ADDENDUM 04

PROJECT:	Exeter Twp ESC	MWS PROJECT NO:	25-049
ADDRESS:	70 Gibraltar Road		
	Reading, PA 19606	ISSUE DATE:	10/30/2026*

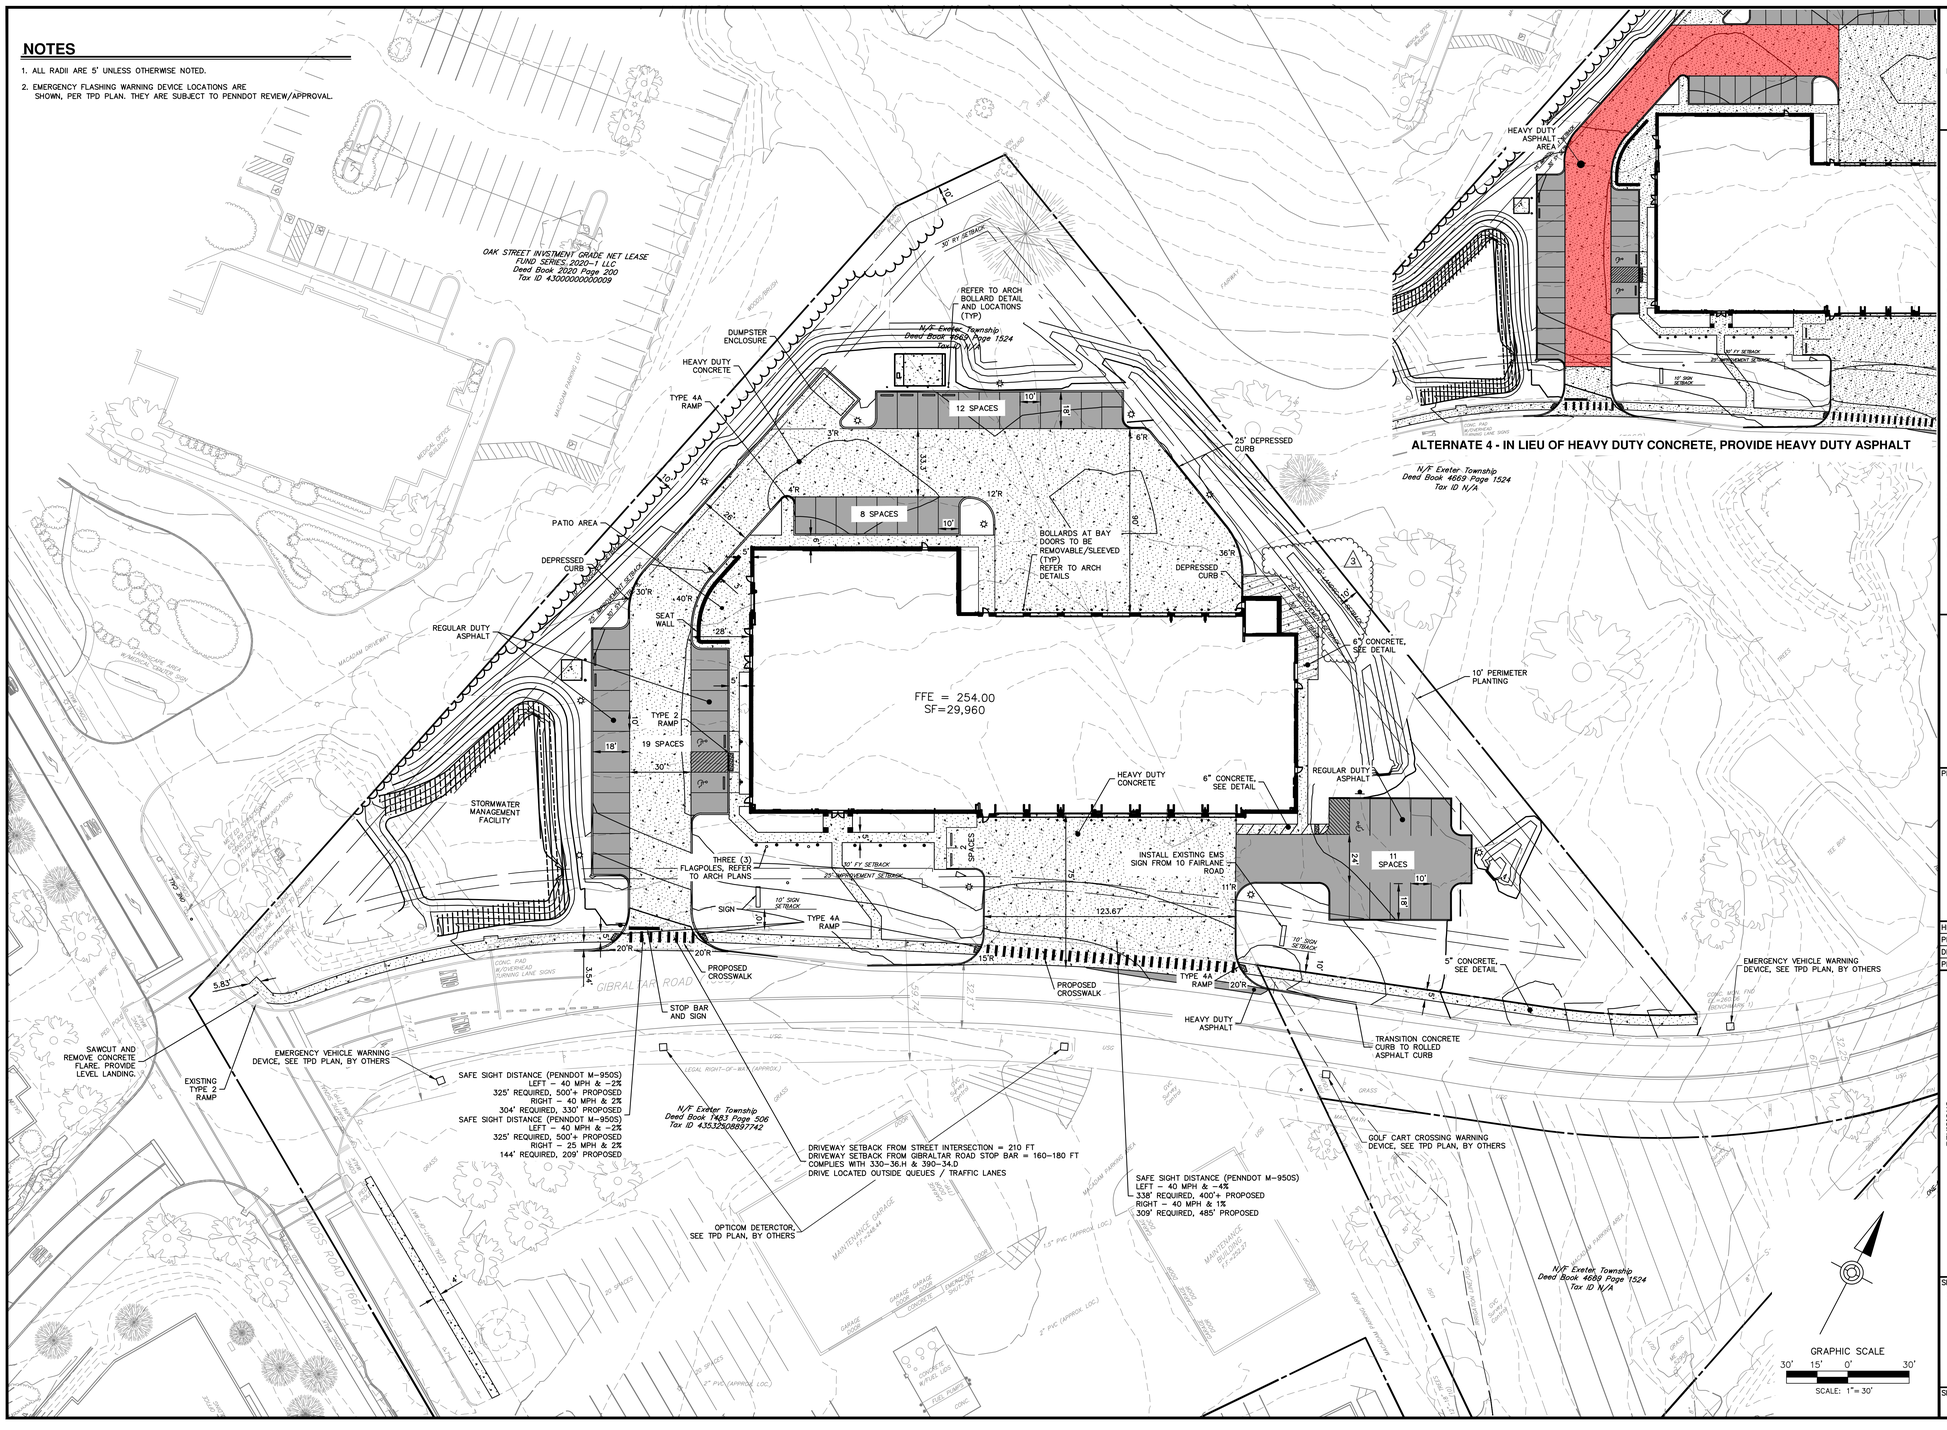
7.) Site Plan (C07) – removed rope anchor note.

SHEET: GR 09

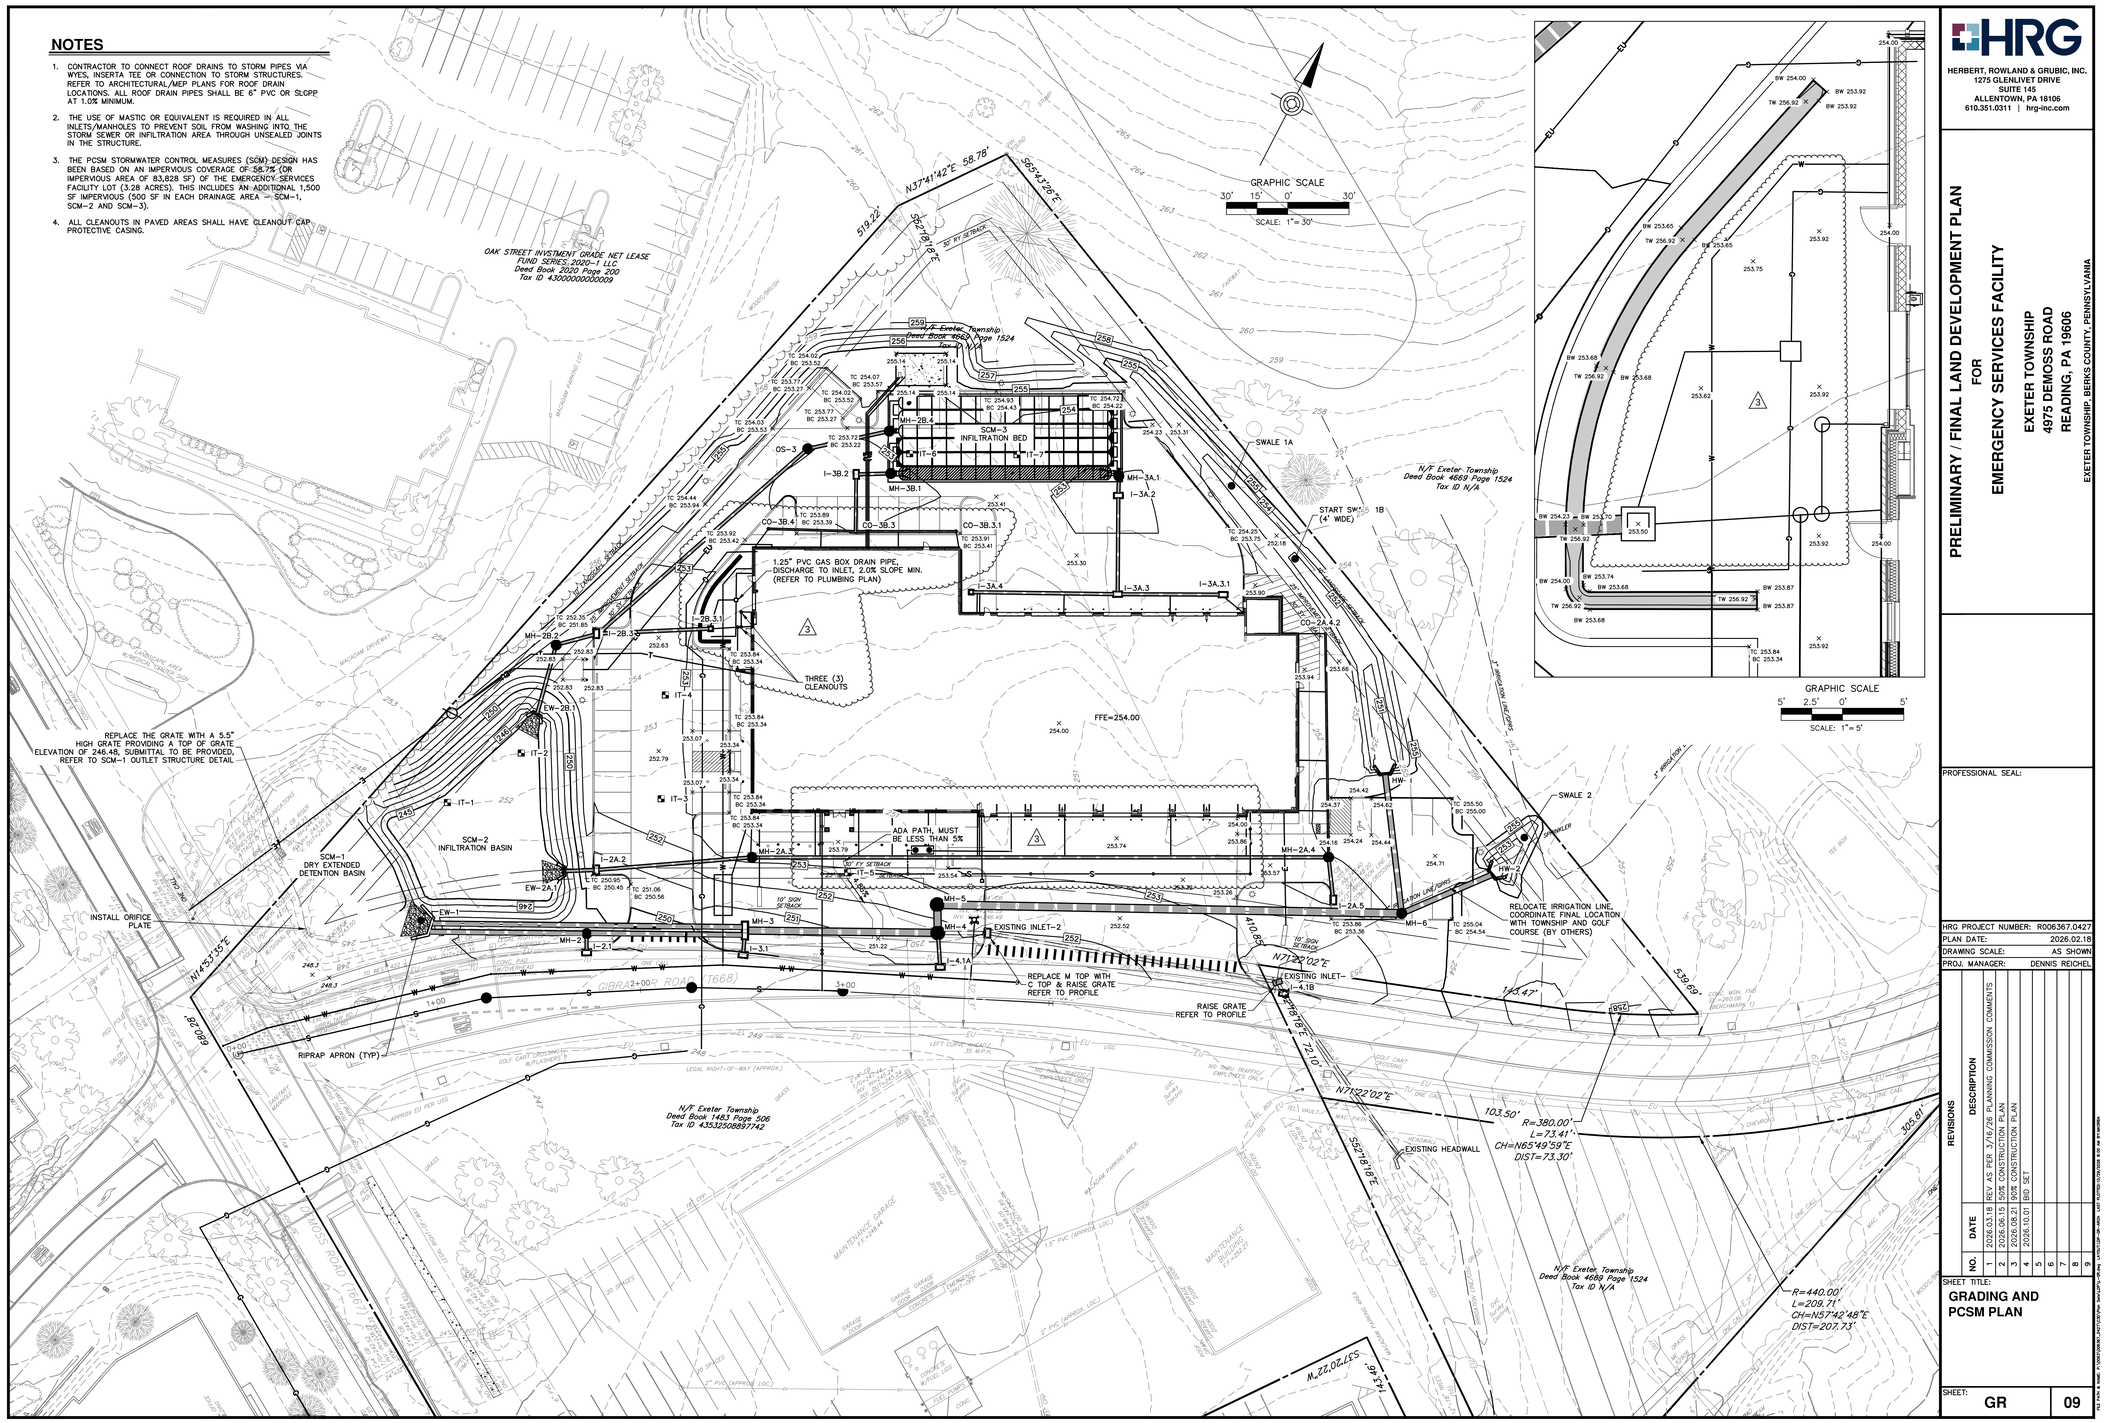
8.) Grading Plan (C08 & C09) – Revised sanitary cleanouts and traps for consistency with Profiles. Revised roof drains to show 26 total. Revised gas service to grills for consistency with Plumbing Plan. Added 1.25" PVC gas box drain pipe label and revised gas box drain pipe to discharge to Inlet (I-2B.3.1). Labeled three (3) additional roof drain storm cleanouts (west side of building).

SHEET: UT 11

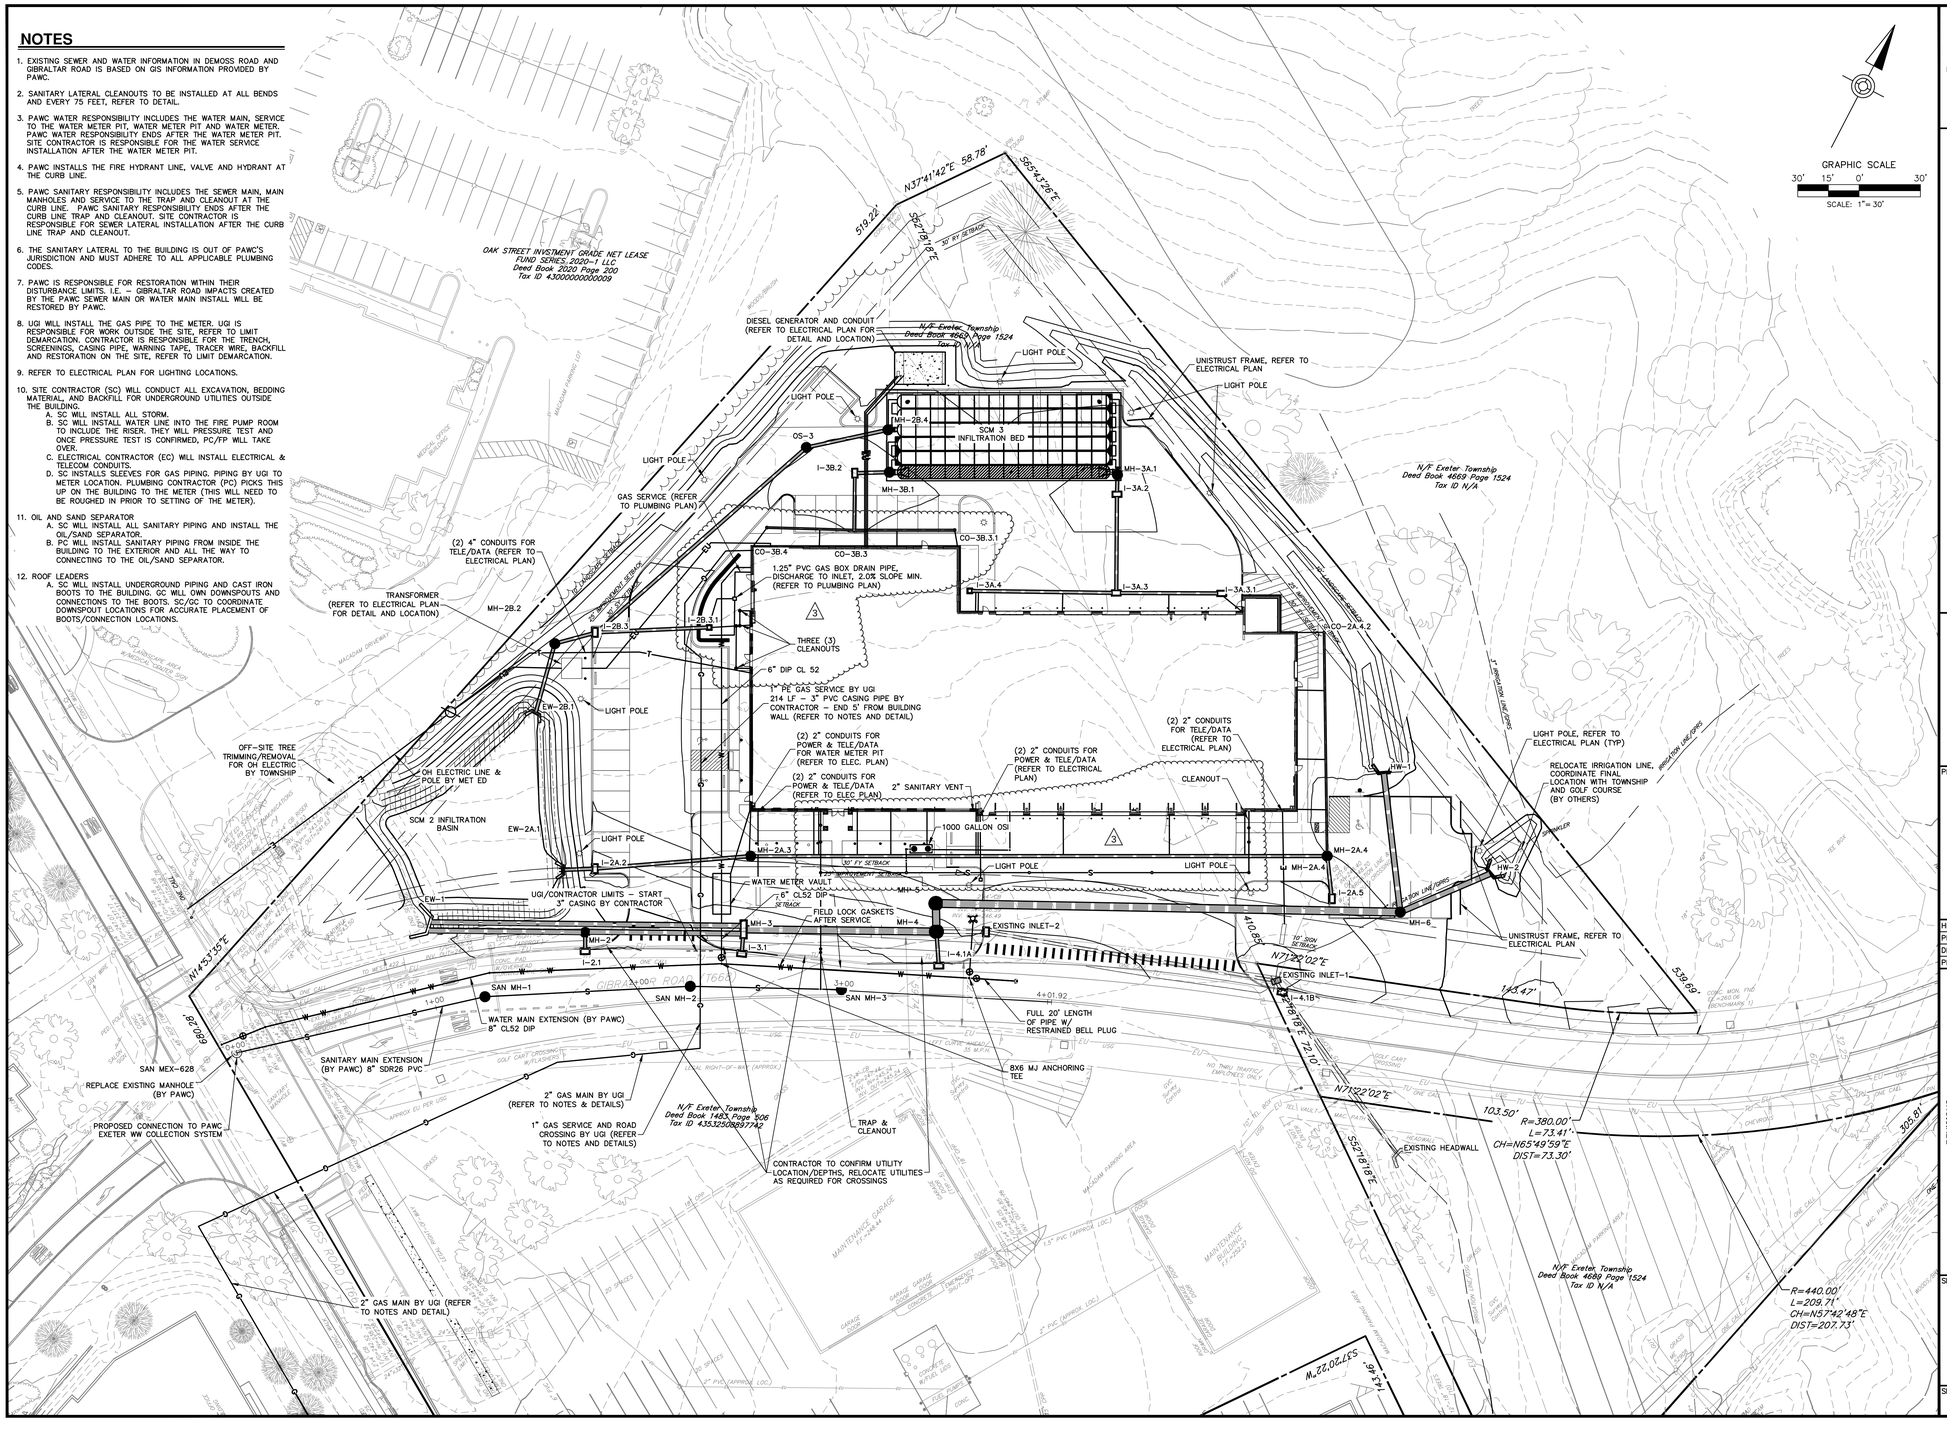
9.) Utility Plan (C10 & C11) – Revised water line label to be DIP CL 52. Revised sanitary cleanouts and traps for consistency with Profiles. Revised roof drains to show 26 total. Revised gas service to grills for consistency with Plumbing Plan. Added 1.25" PVC gas box drain pipe label and revised gas box drain pipe to discharge to Inlet (I-2B.3.1). Labeled three (3) additional roof drain storm cleanouts (west side of building).

RESPONSE: SC is responsible for installation of the flanged riser in the building. The water line between the meter pit and building was revised to be 6" DIP CL 52. The labels on sheet C11 and C12 were revised. The water specification was revised to eliminate PVC pipe and require DIP, refer to spec section 33 1416.

I-2B.3.1 TO I-2B.3 ⚠3

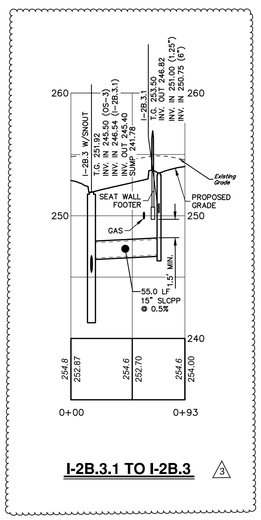
10.) Profiles (C12, C107, C207) – EW-2A.1 to I-2A.5 – water line crossing revised to be DIP CL 52. I-2B.3.1 to I-2B.3 – added pipe inverts to I-2B.3.1

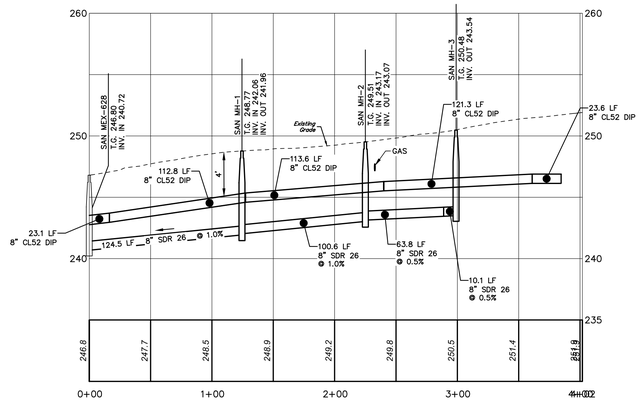
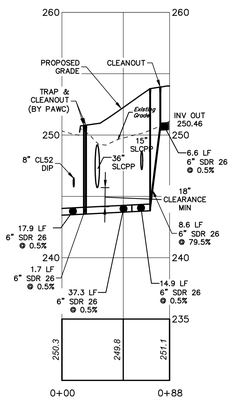
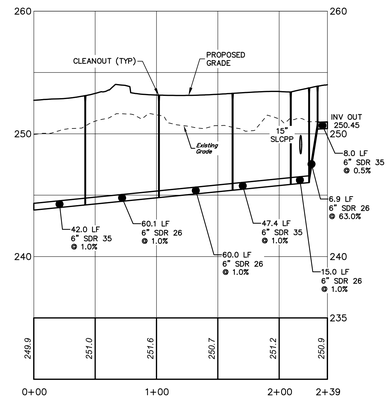
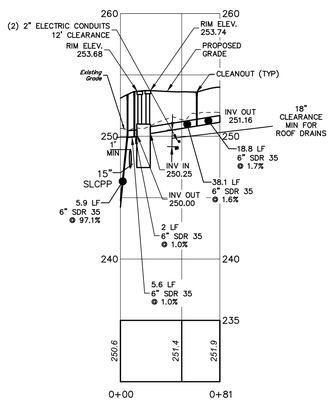
11.) Profiles (C13, C108, C208) – Revised three (3) sanitary lateral profiles for cleanout and trap consistency with Plans.

EXISTING HEADWALL ORIFICE PLATE DETAIL (SCM-1)

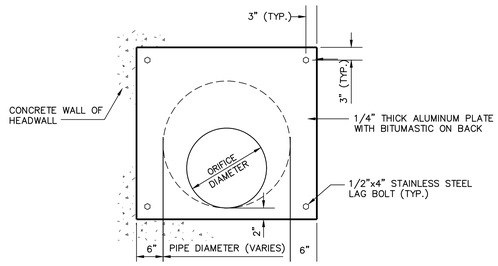
71.) QUESTION: For SCM-1, please confirm no modifications are required to the existing outlet structure other than replacing the grate.

RESPONSE: For the SCM-1 box outlet structure that is correct. There is also a separate SCM-1 HW outlet structure that requires an orifice plate. Refer to sheets C09 and C25.

INFILTRATION BED (SCM-3) DETAIL

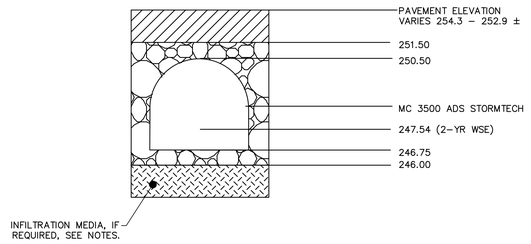
72.) QUESTION: For SCM-3, Is Infiltration Media required under the stone bedding? If so, what is the required depth?

RESPONSE: Refer to SWCM-3 detail notes 1-3, sheet C25. Media is only required if rock or perched water is encountered. The depth is 2 feet, if this is required. The construction manager will be adding an allowance, should this be needed.

STORM CLEANOUT DETAIL IN PAVED AREAS

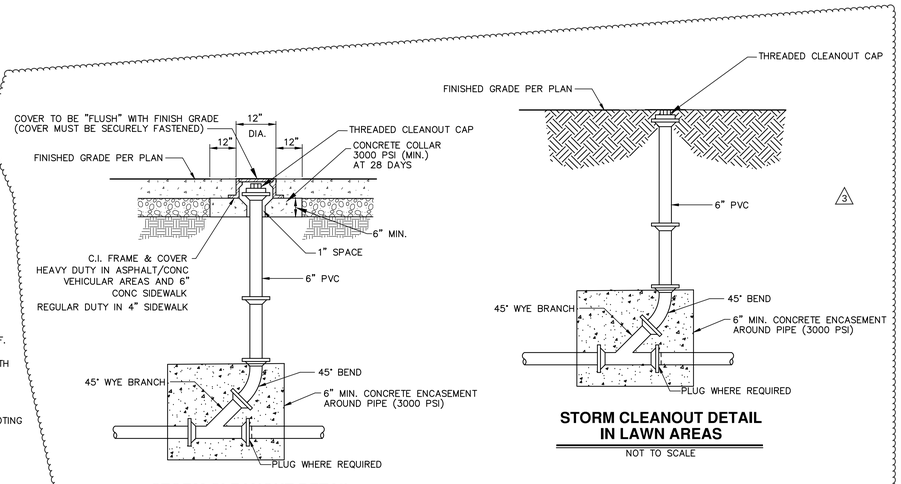
13.) Details (C25 & C211) – Added two (2) storm cleanout details.

74.) QUESTION: Please provide a detail for the storm cleanouts (CO-2A.4.2, CO-3B.3, C0-3B.4, CO-3B.3.1). Similarly, please provide a detail for the roof drain cleanouts.

RESPONSE: Storm cleanout details added to sheet C25. No roof drain cleanouts are proposed. If the question pertains to downspout cleanouts, refer to the detail on sheet C22. Three (3) storm cleanouts were added upslope of Inlet I-2B.3.1 (west side of building), refer to sheets C09 and C11. All roofs drain via gutter to downspout and no cleanout is required aside from the cleanout provided at the boot.
